**WATER RESOURCES INTEGRATION PROGRAM, PHASE 1 PIPELINE SEGMENT 2A**  
**Solicitation No. B-14-045-DD**  
**SAWS Job No. 14-8605**

**ADDENDUM NO. 4**  
**SEPTEMBER 26, 2014**

**2A ADDENDA 4  
 ATTACHMENT 5**

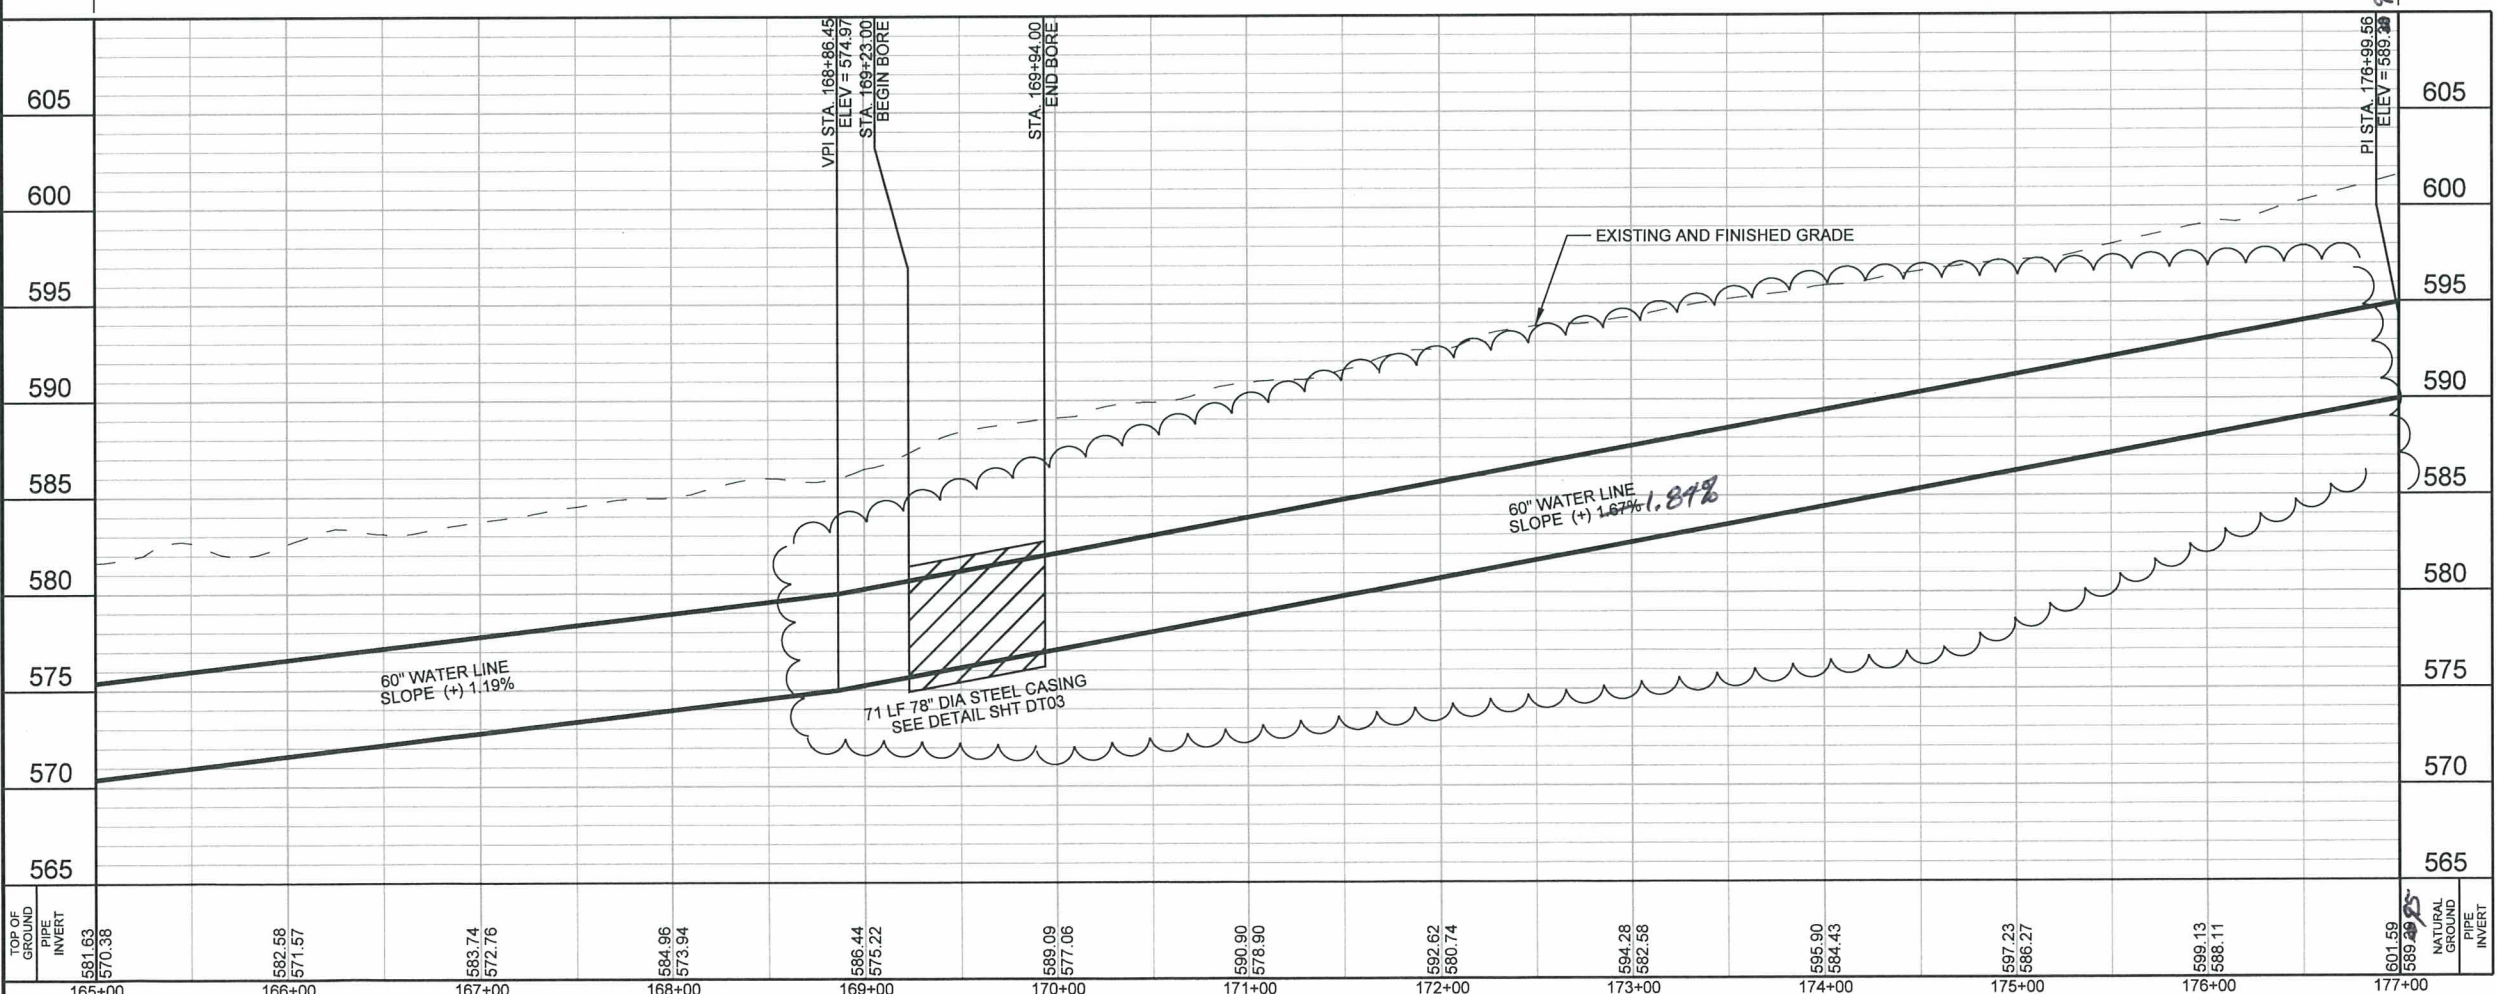
1. Remove and Replace Sheet PP14 and PP15, primarily to reflect the addition of a recently installed 16 inch waterline in TXDOT right of way oriented generally parallel to the north ROW line of Loop 1604, including adjustments to the proposed pipeline profile and pipe quantities. Revised alignment information and corrected quantities matching those indicated on the Price Proposal will be provided with the conformed plan set. (See Attachments 5 and 6).
